palisades preservation association

December 31, 2014

**LETTER IN SUPPORT OF APPEALS FROM THE DECISION OF THE
ZONING ADMINISTRATOR TO APPROVE A MITIGATED NEGATIVE
DECLARATION AND A COASTAL DEVELOPMENT PERMIT FOR 16990-
17000 SUNSET BLVD., PACIFIC PALISADES, (ZA 2012-0130(CDO) AND
ENV-2012-031(MND)**

June 13,2013 Accident Across From 17000 Sunset

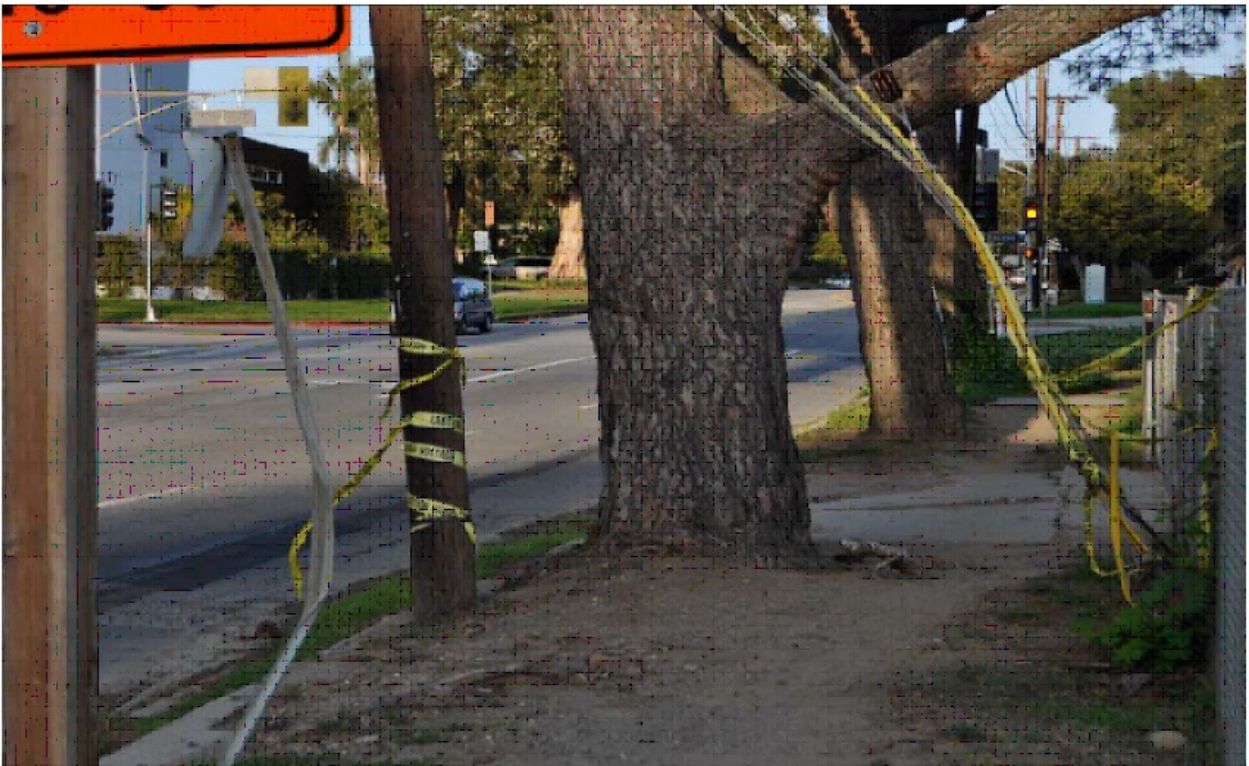
At the hearing, which Mr. Hilton attended, there was considerable testimony as to the number of accidents that occurred in the area studied by Mr. Hilton and also many complaints about the speeding in that area including testimony about a fatal motorcycle bus collision at the intersection of Marquez Ave. and Sunset. Yet he accepted the SWITRS data as correct.

Locations of Accidents 2010-2013

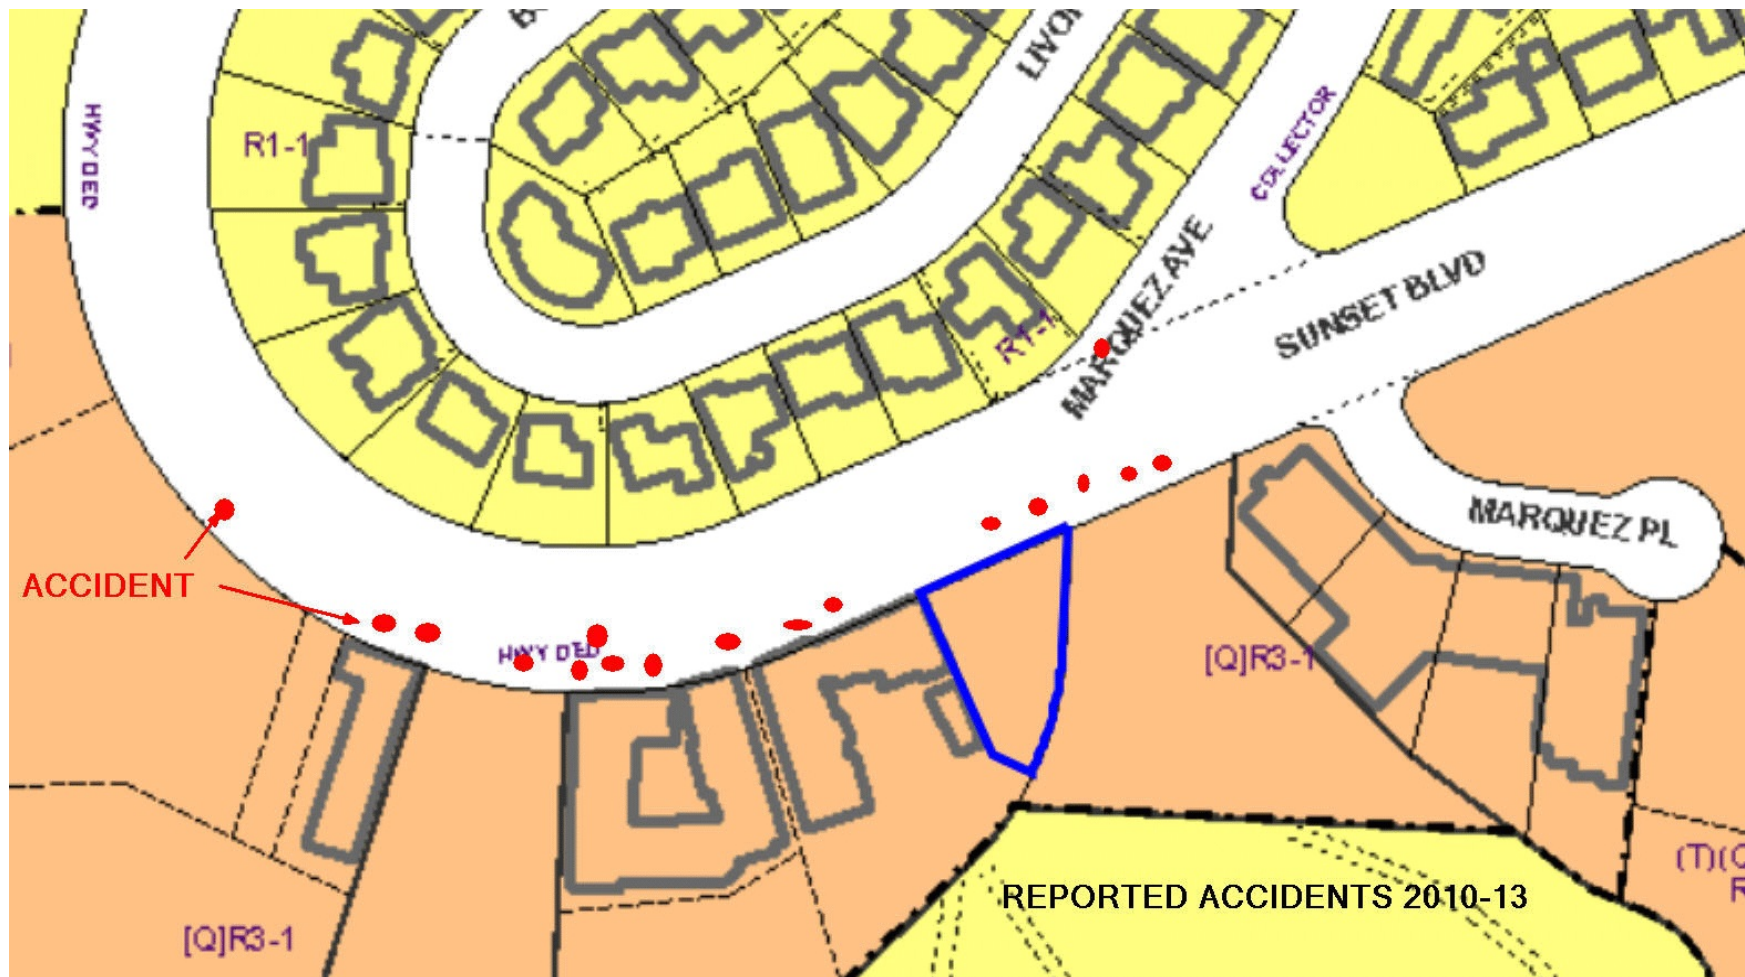
On the next page is a map indicating the approximate location of each accident with red dots.
